# 2022 RTEP Window 3 Changes

Susan McGill Sr. Manager, Strategic Initiatives

## Rationale for the Scope Change

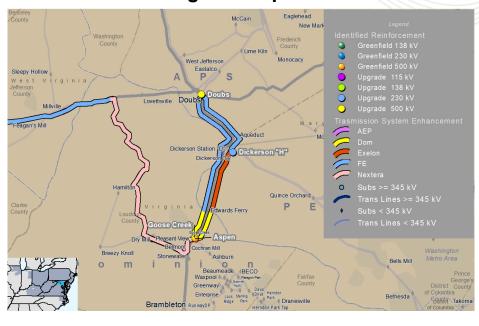
The line section from Woodside to Aspen will be rerouted from the originally proposed greenfield line route to an alternate route within existing transmission line rights of way along the Doubs Corridor containing the rebuilt Doubs – Goose Creek and the new Doubs – Aspen 500 kV lines. This reroute is the outcome of successful collaboration between NextEra and the incumbent Transmission Owners to determine the most feasible route and minimize area impact for the new Woodside to Aspen 500 kV line segment.

As part of this change, the new 500 kV line from Woodside will now terminate into Goose Creek substation due to space constraints within the Corridor and also to minimize unnecessary line crossings.

## Scope Change

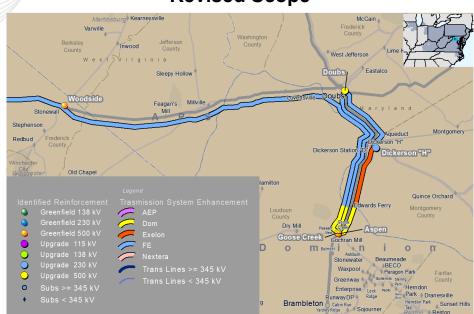
Revised scope increases the total line length by 5 miles.
